LINCOLN CITY/LANCASTER COUNTY PLANNING STAFF REPORT

P.A.S.: Preliminary Plat #02021
EDM Business and Industrial Park

PROPOSAL: To create 31 lots for commercial and industrial development.

Engineering Services has reviewed the resubmitted West 'O' EDM Business and Industrial Park Preliminary Plat, located south of West O Street at 32nd Street and has the following comments:

SITE
PLAN

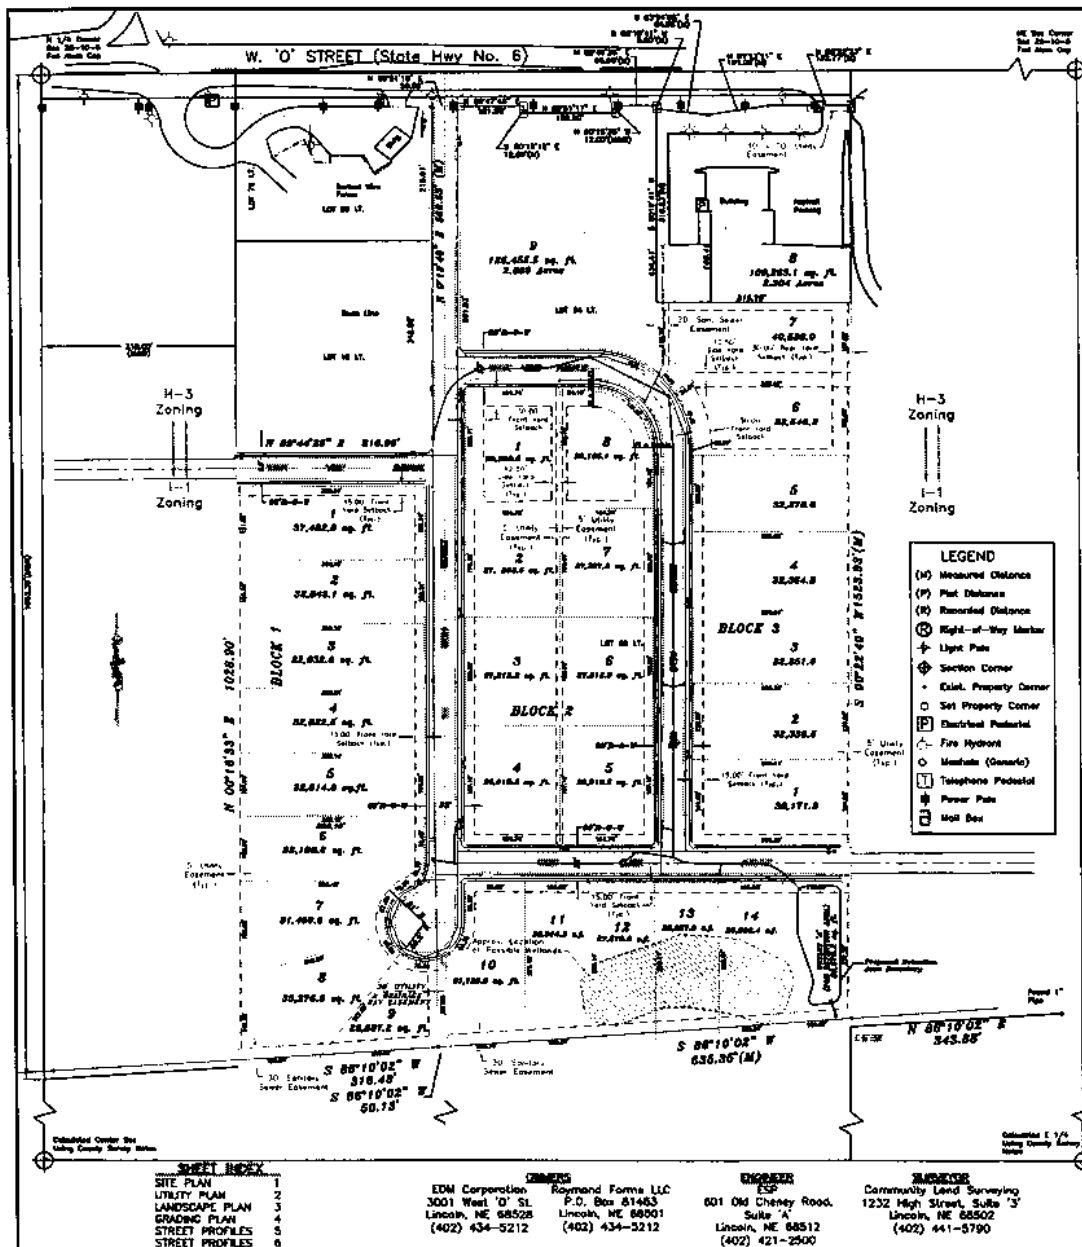
1. The subdivision ordinance requires 66' wide rights-of-way, with 33' wide streets for commercial and industrial developments. Southwest 32nd Street is shown having 50' of right-of-way between West O Street and West View Avenue. Because the adjacent lands to the west are not included in the plat, only half the right-of-way must be dedicated with this development. This requires another 8' of right-of-way, or 33' east of the centerline, to be dedicated with this plat. Additionally, West View Avenue is shown as having a 63' wide right-of-way, but 66' must be provided.

5. Several minor corrections must be made to the plat including: the surveyor's certificate must be signed; provide a graphic scale on Sheet 1 of 6; move the zoning boundary between H-3 and I-1 as it is actually located south of the right-of-way line of West View Avenue; and, provide minimum opening elevations for lots adjacent to detention areas or drainage ways.

- 1.1 Revise the preliminary plat to show:
 - 1.1.1 33' wide right-of-way east of the centerline of Southwest 32nd Street between West O Street and West View Avenue
 - 1.1.2 66' wide right-of-way for West View Avenue.
 - 1.1.3 A signed surveyor's certificate.
 - 1.1.4 A graphic scale on Sheet 1 of 6
 - 1.1.5 The zoning boundary between H-3 and I-1 in the actual location.
 - 1.1.6 Minimum opening elevations for lots adjacent to detention areas or drainage ways.
 - 1.1.7 Additional utility easements as noted in the May 9, 2003 L.E.S. review.
 - 1.1.8 Lot 8 with frontage to an abutting sewer.
- 1.2 The required corrections noted in the Public Works review, including a revised grading and drainage plan approved by Public Works and Utilities.
- 1.3 A water system plan approved by Public Works and Utilities.

GRADING PLAN

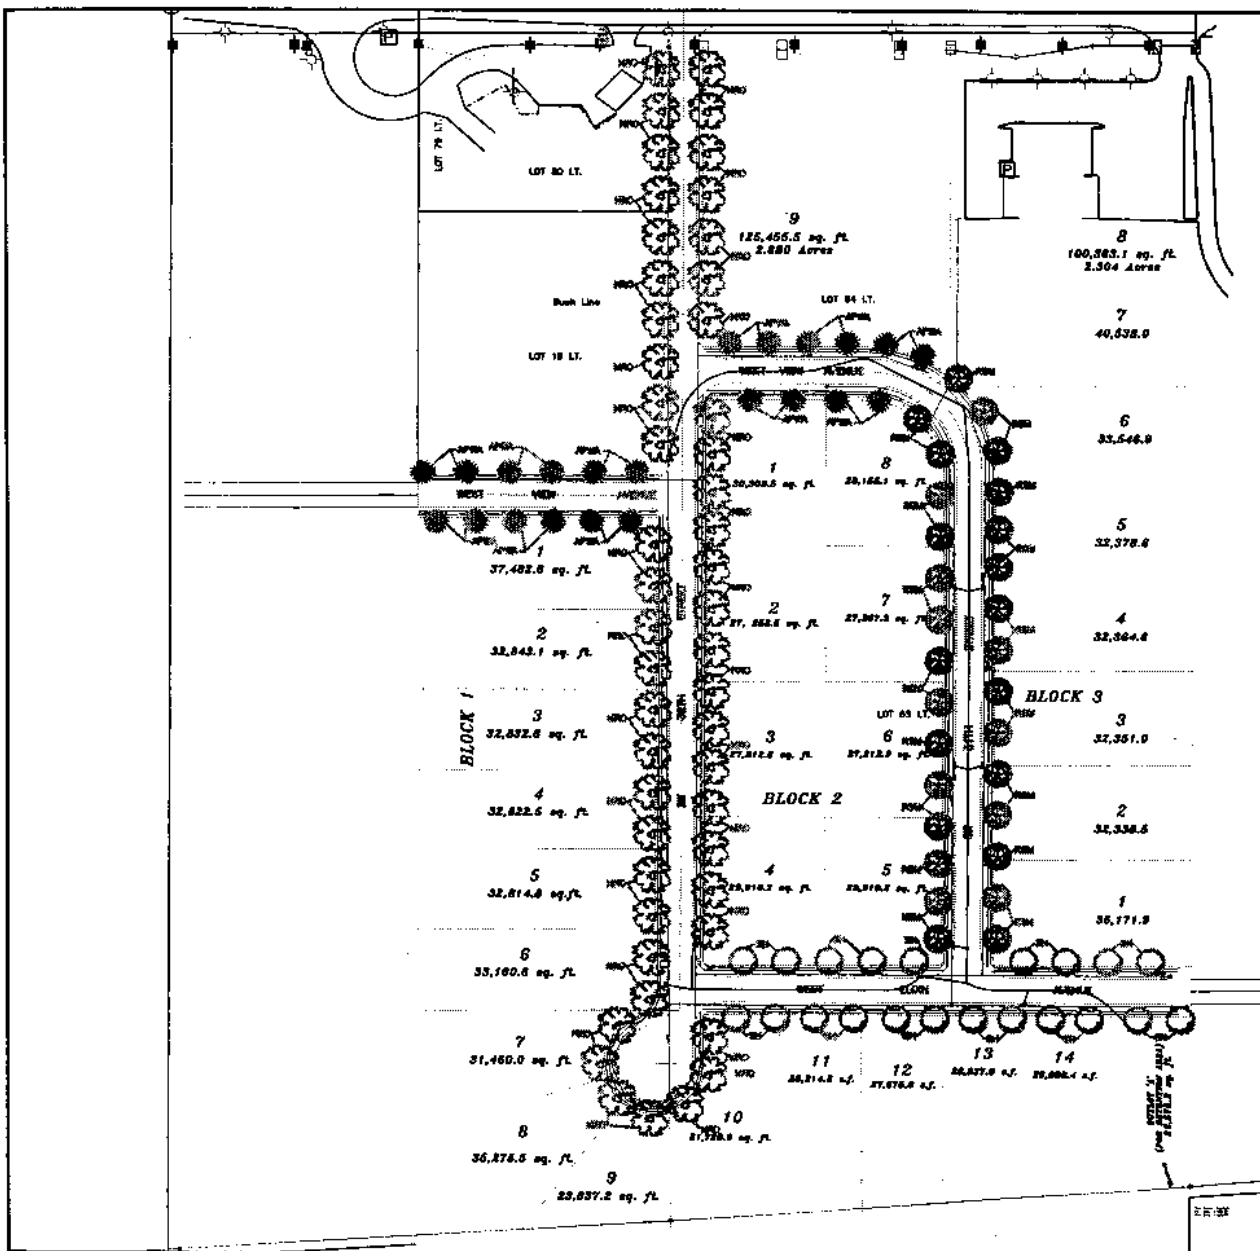
- Grading/Drainage - The contours in the east end of Elgin Avenue show a non-standard paving cross section. This is unsatisfactory and the contours need to be revised to show a cross section consistent with design standards.

- There does not appear to be an overland flow path for any storm greater than the 10 year storm. Elgin Avenue slopes to the east at 0.5% from Southwest 32nd Street to the east property line without a low point to route the flow into the detention cell. Since the storm sewer is designed for the 10 year storm, any flow greater than the 10 year storm will flow off site to the property east of this project. Provisions need to be made to route the runoff to the detention cell.

- There is no emergency overflow shown for the detention cell. The detail for the outlet structure shows an elevation for the top of the weir to be 1166.08 and the contours for the bank of the detention cell show the top to be at 1166 on the south and west sides and 1165 on the north and east sides. This situation will cause overflow onto the adjoining lots to the east and west of the detention cell. An emergency over flow is required at the south end of the detention cell with no less than 1.0' from the overflow elevation to the top of the detention cell.
